Notification of Decision to Grant Permission/~~Application~~

To: Dermot Walsh Architects, Decision Order P/3358/91 19.07.91
Florence Centre, Number and Date
Florence Road, Register Reference No. 91A/0416
Bray, Co. Wicklow, Planning Control No.
Application Received on 22.03.91.
Applicant Cavvies Ltd. A.I. Recd. 31.05.91 Floor Area: 846.5 sq.m.

retention of alterations and additions to the Jensen Hotel inclusive of seven bedrooms, kitchen block, lounge and function room, and relocation of fire escape route at Ninth Lock Road, Clondalkin.

Report of the Dublin Planning Officer, dated 18 July 1991.

F I R S T S C H E D U L E

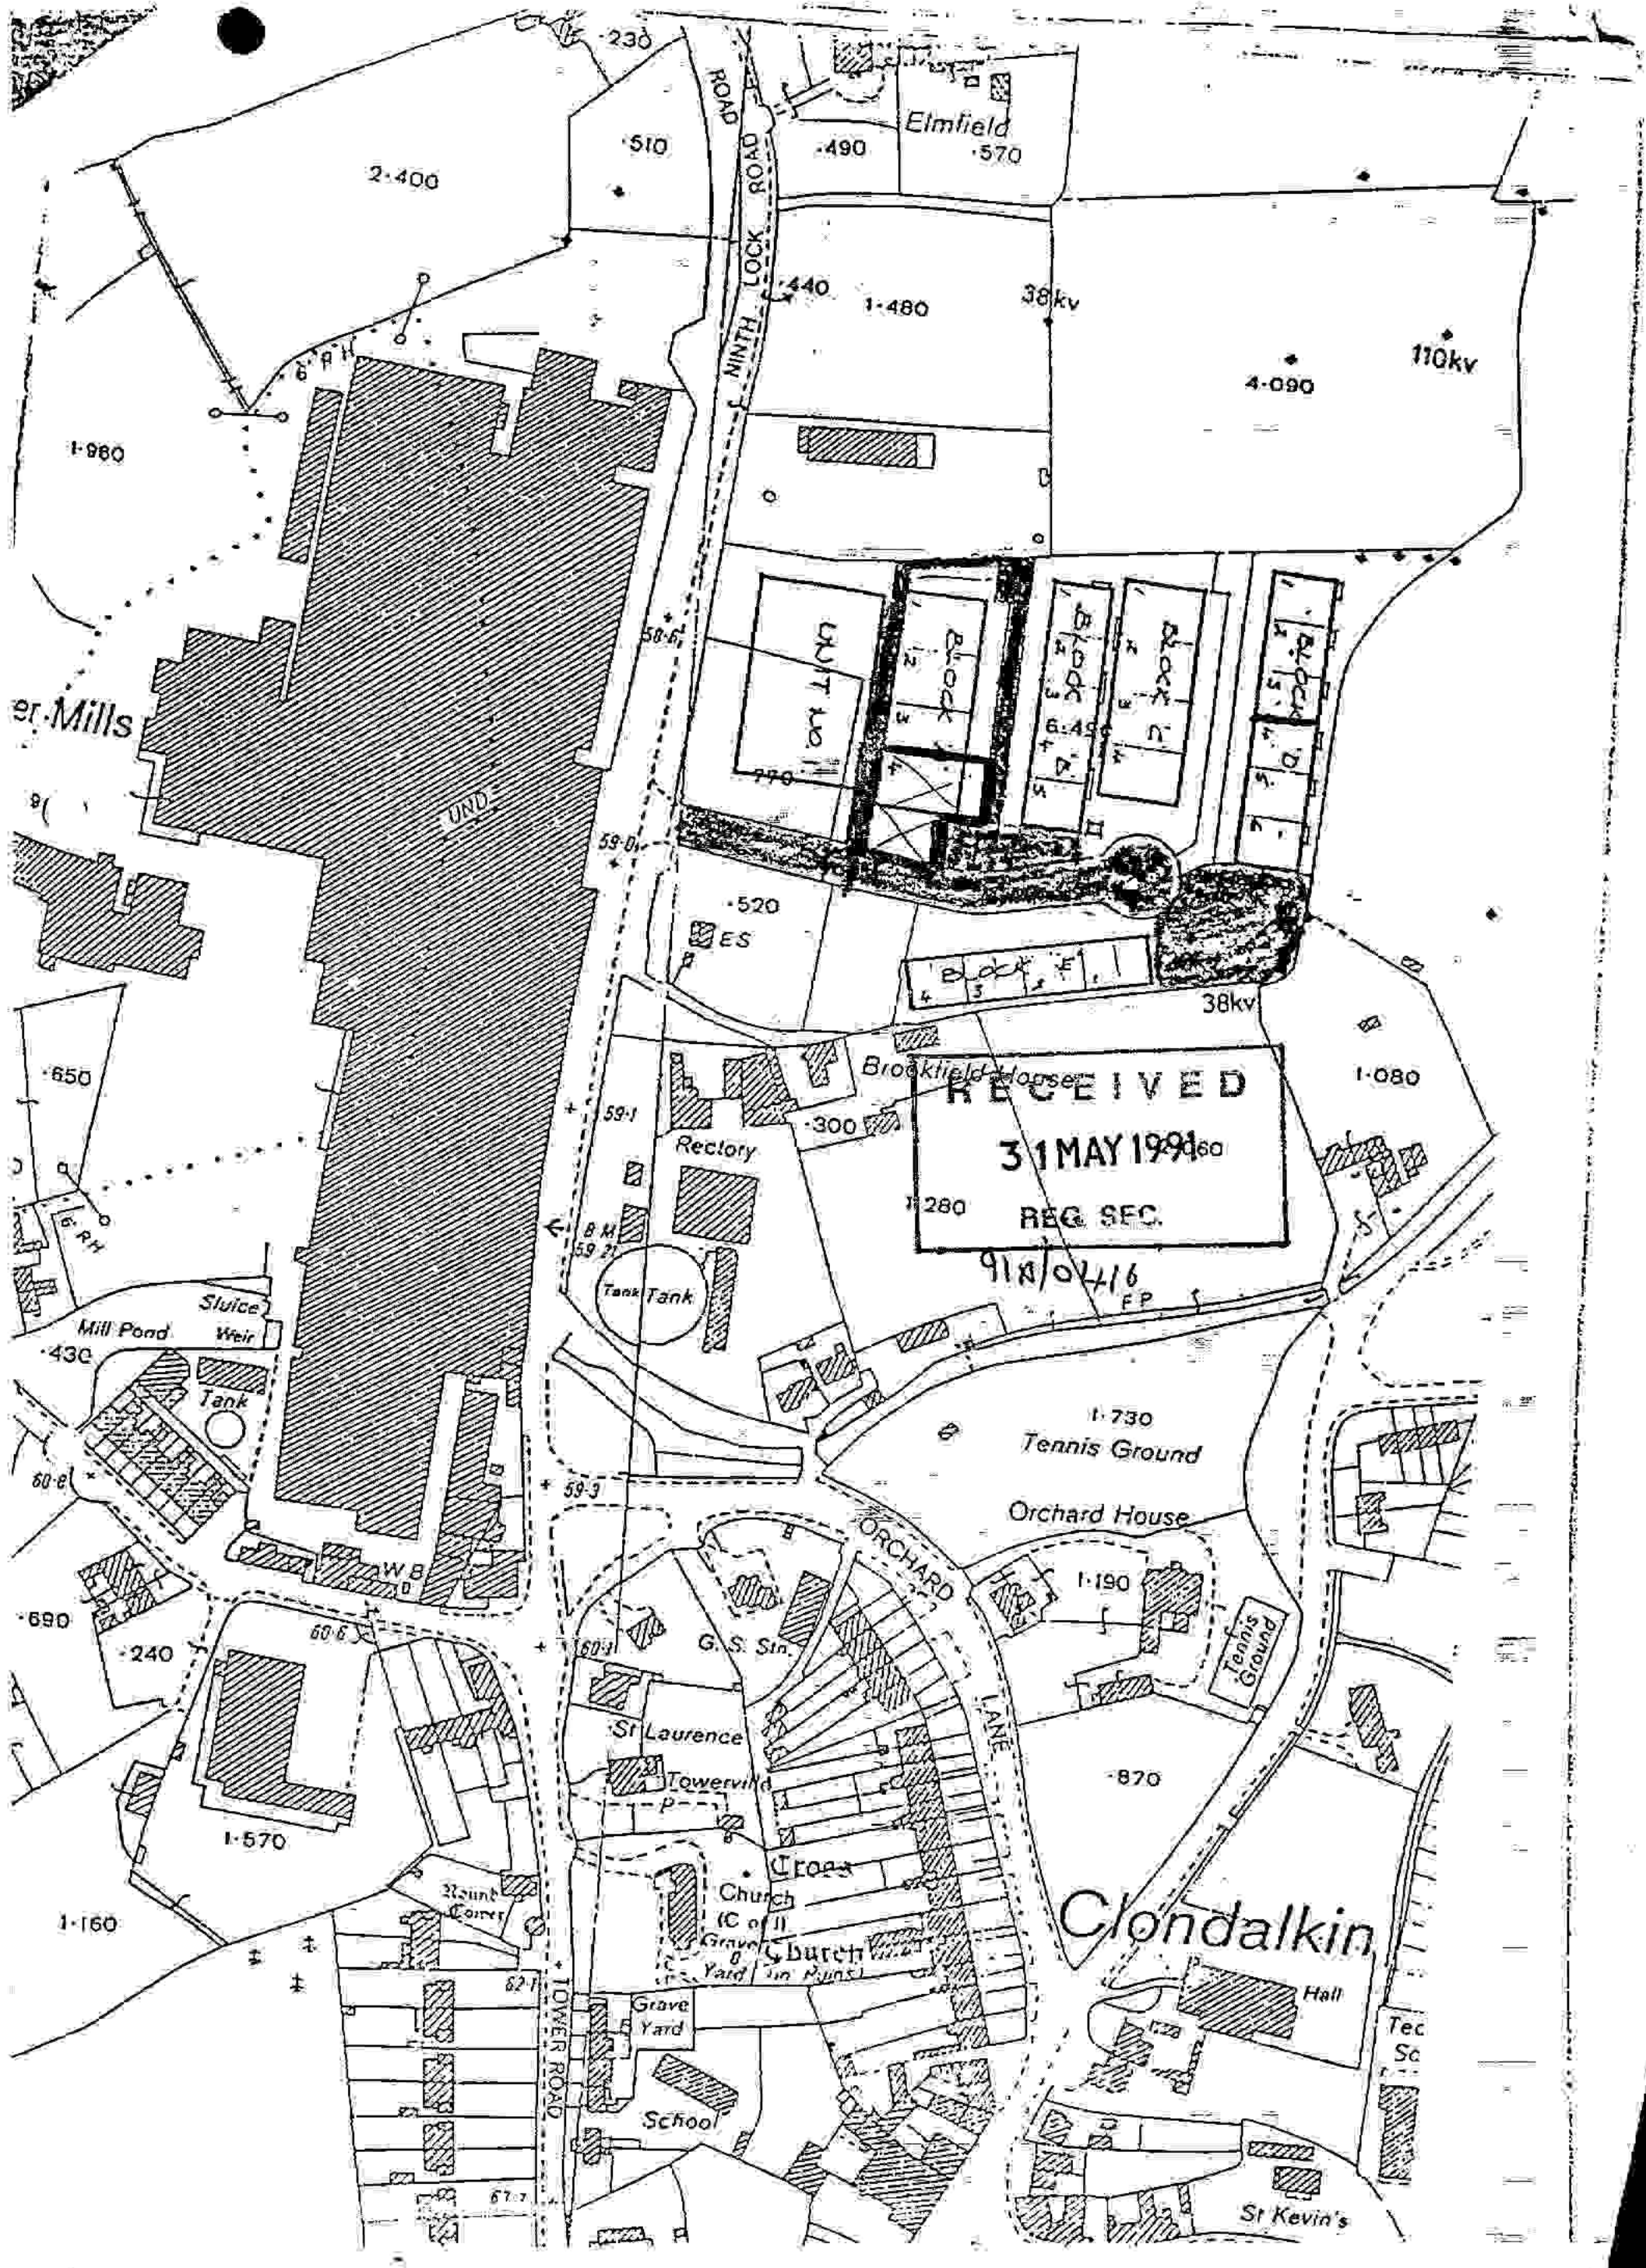
1. At all times by day and by night with or without horses, carts, motor cars, and motor lorries and all other manner of vehicles howsoever propelled or drawn laden or unladen to go pass and repass over and along the roadway car parks and footpaths coloured yellow/^{and green} on the map annexed hereto.
